Re: Recall No. 08V-047 Supplemental Information

MODEL: 2008 CONCOURS™ 14/14 ABS (ZG1400A8F/L, ZG1400B8F/L)
TITLE: SADDLEBAG LATCH REPLACEMENT

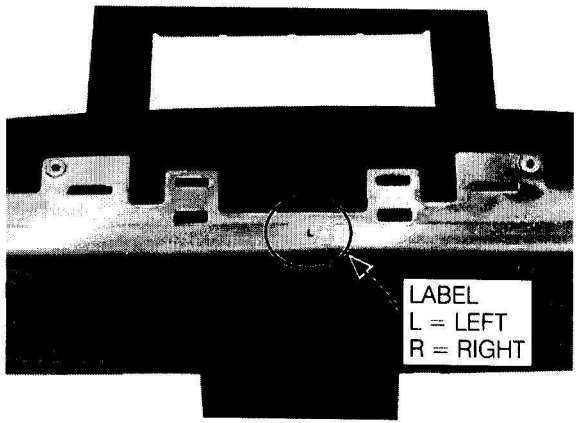
- Match the label on the latch assembly to the appropriate saddlebag.
L: left side R: right side

- Install the new latch assembly on the saddlebag using the screws and washers removed previously and tighten the screws.

Torque
0.6 N-m (0.06kgf-m, 5.3 in-lb)

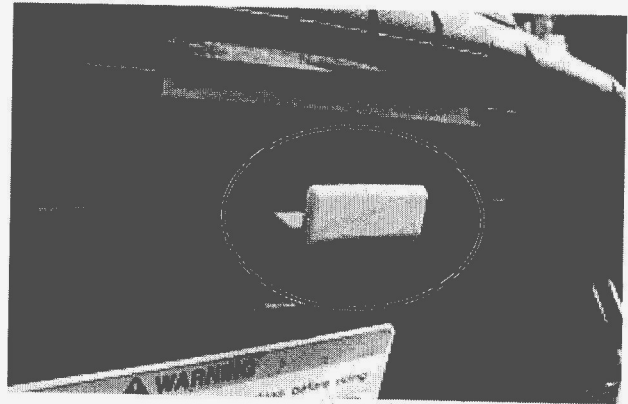
The latch color will serve as repair verification.

OLD: RED . . . NEW: ORANGE
